Work Order ID 150952

Item Name: 206A/B Bearpaws

DART SERVICE INSTRUCTION

TO AMEND INSTALLATION INSTRUCTIONS D206-559 REV. K OR EARLIER AND
INSTRUCTIONS FOR CONTINUED AIRWORTHINESS ICA-D206-559 REV. 2 OR EARLIER

FIGURE 4: TYPICAL CLAMPING DETAIL (D206-559)
FIGURE 32-3: TYPICAL CLAMPING DETAIL (ICA-D206-559)

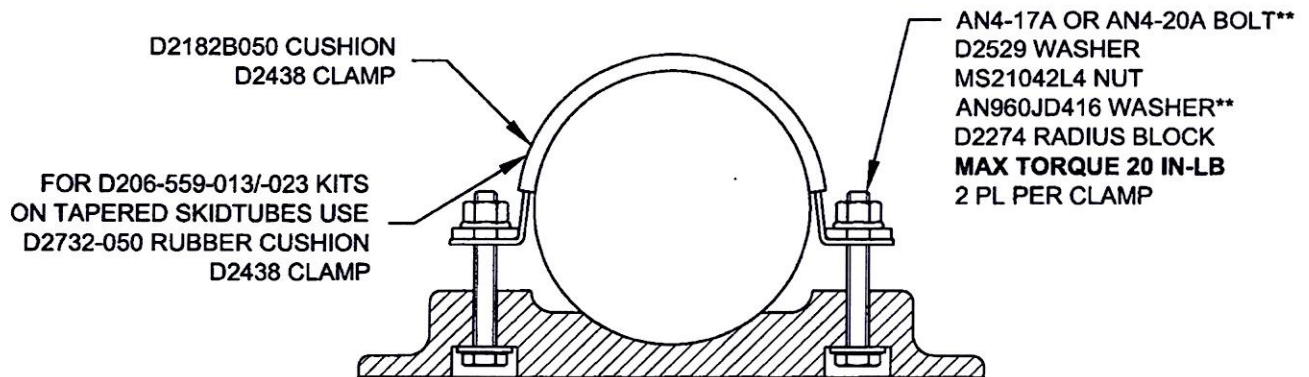
For D206-559-011/-013/-021/-023/-031/-033 bearpaw kits, the AN4 bolts specified were for installation with the aft skidtube wearshoe removed. Bolt lengths are increased to accommodate installation with the skidtube wearshoe installed, which is more practical.

Figure 4 of D206-559 and Figure 32-3 of ICA-D206-559 are amended as follows:

**USE AN4-17A BOLTS WITH AN AN960JD416 (OR NAS1149D0463J) WASHER IF INSTALLING BEARPAW ON 3.0" DIA. TUBE OR SMALLER. USE AN4-20A BOLTS WITH TWO AN960JD416 WASHERS IF INSTALLING BEARPAW ON TUBE LARGER THAN 3.0" DIAMETER (DART TUBE). ADDITIONAL AN960JD416 WASHERS MAY BE ADDED UNDER NUT TO ENSURE 2-4 THREADS IN SAFETY. IT IS ALSO ACCEPTABLE TO USE LONGER/SHORTER AN4 BOLTS IF REQUIRED TO ENSURE BEARPAW IS HELD SECURELY.
